# KERR-McGEE CORPORATION

## APPLICANTS ENVIRONMENTAL REPORT

Uranium Hexafluoride Plant

Please refer to your letter of December 6 raising certain questions or requesting additional information in regard to our Revised Environmental Report of November 1971 and our Supplemental Environmental Report of June 1972.

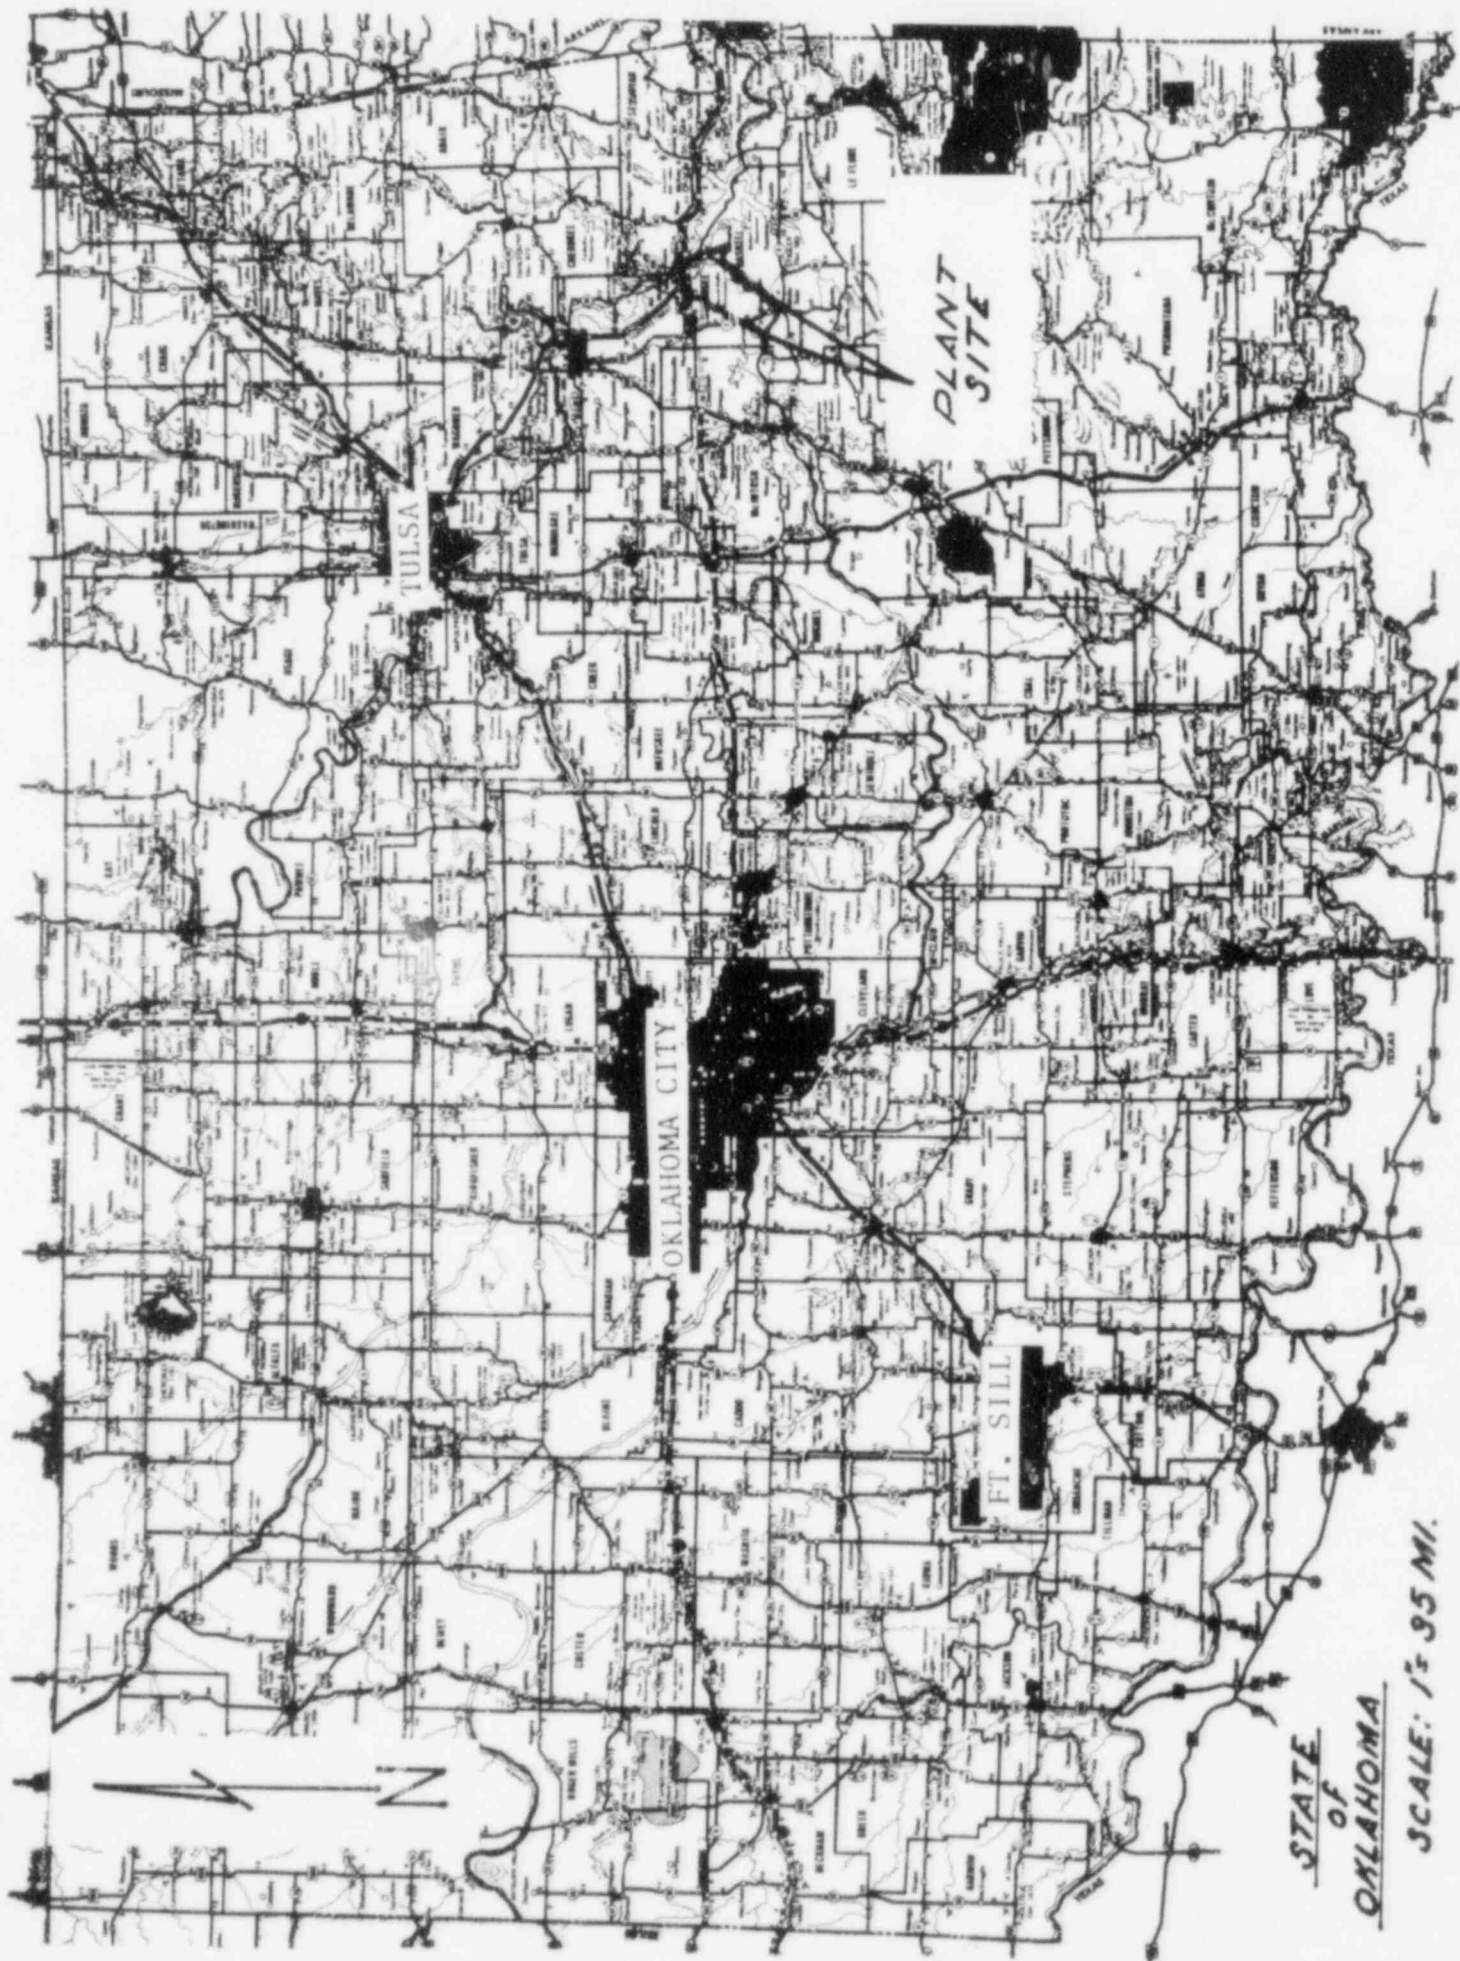
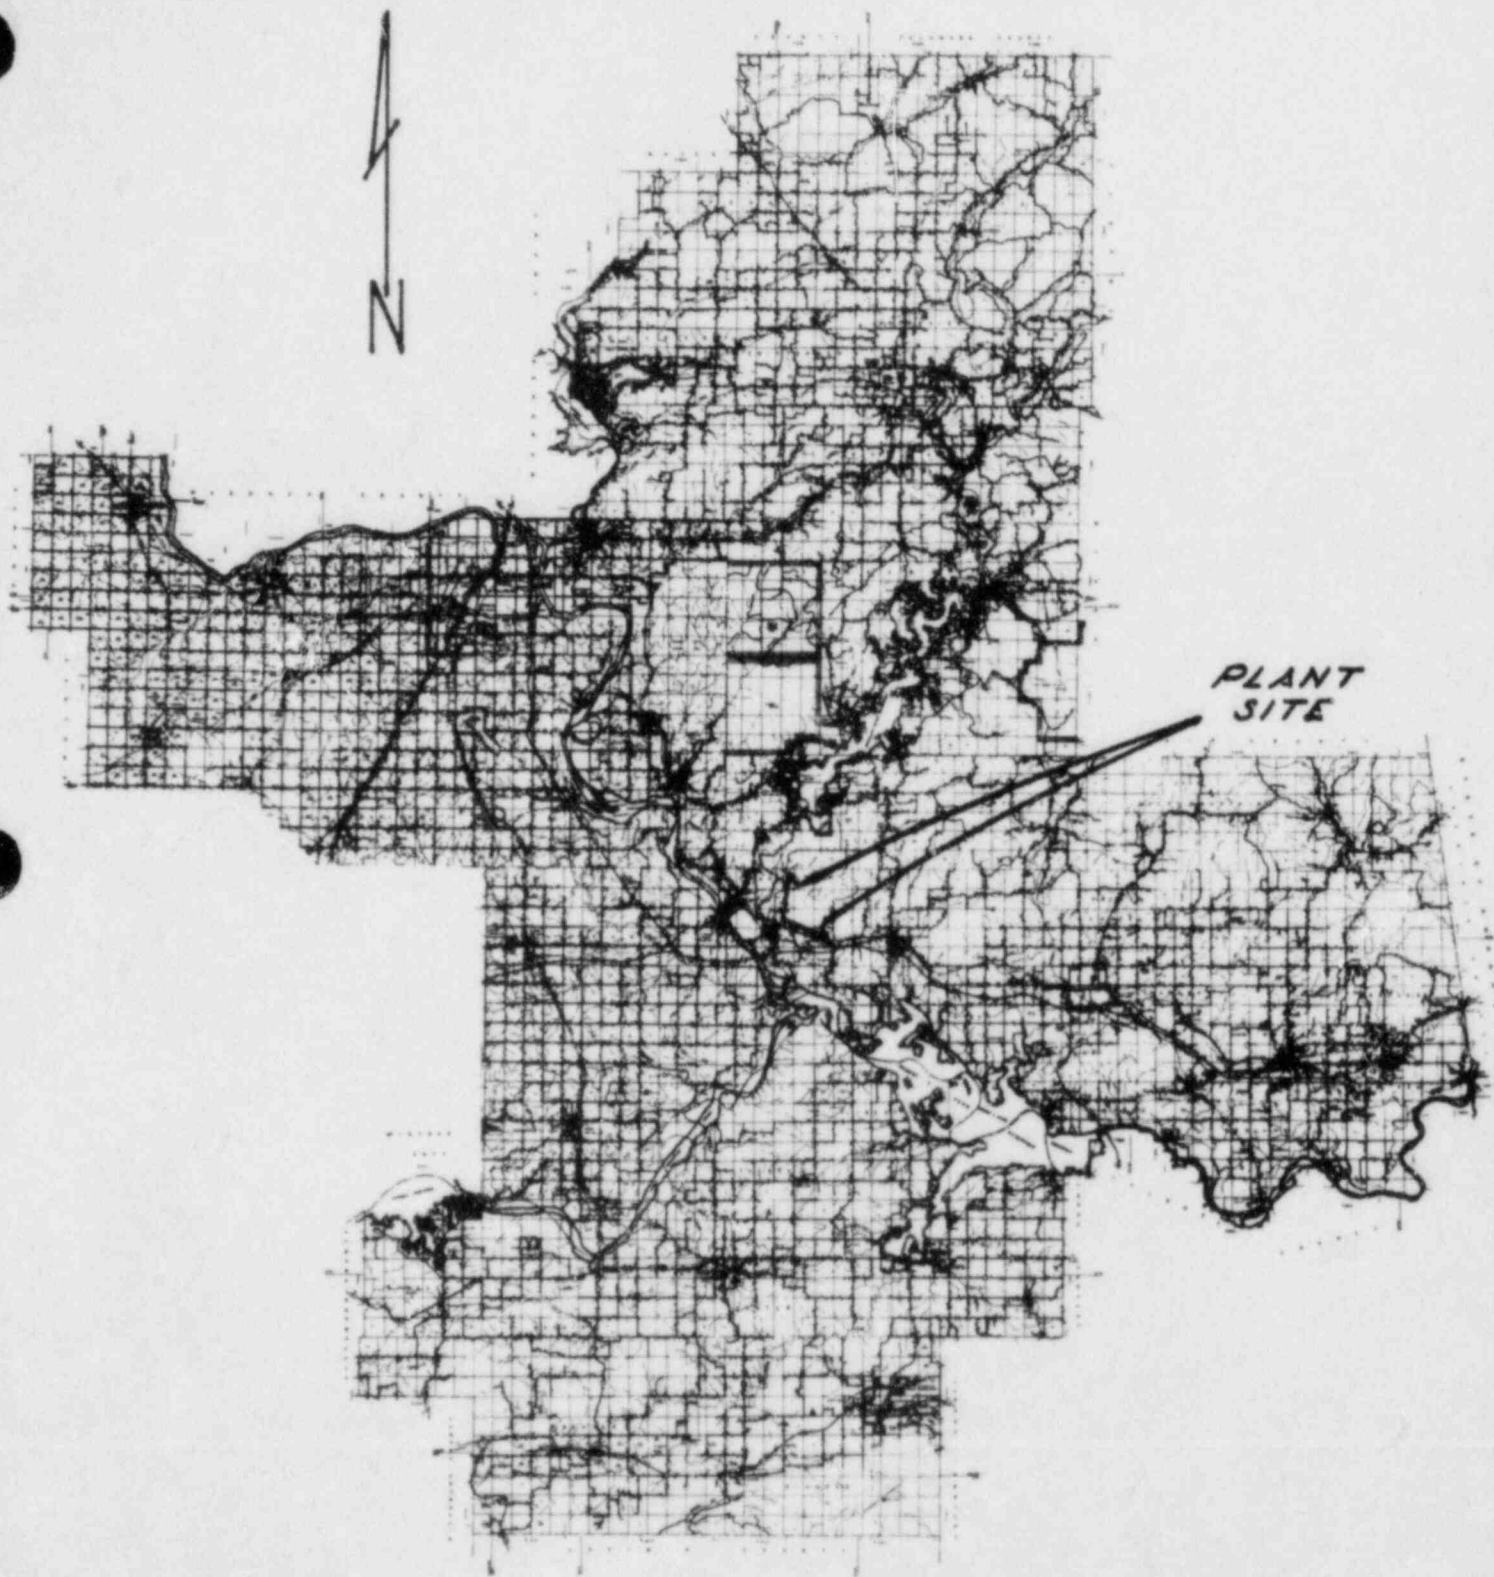
- (2) Maps provided (Figure 1 in particular) are not very clear. Suggest substituting following 8 x 10 1/2" drawings:
- (a) General map of State of Oklahoma pointing out plant site (scale about 50 miles per inch),
  - (b) Second map showing general area details i.e., towns, roads, rivers, etc. (scale about 10 miles per inch)
  - (c) Third map similar to insert in present Figure 1. (scale about 4 miles per inch)
  - (d) Plant area map (scale about 1500 feet per inch) up-dated to show all existing ponds, monitoring points, residences, etc. alone with distances from air-borne effluent release point to possible critical exposure points; e.g., school, homes, roads.

The maps requested are enclosed. We feel, however, that this request, if such fixed criteria for such reports exists, should be included in the guidelines for such reports. Figure 1 is a reduction of Drawing 110-C-151 included with the Revised Environmental Report. The location of the houses and school are circled and the distances tabulated.
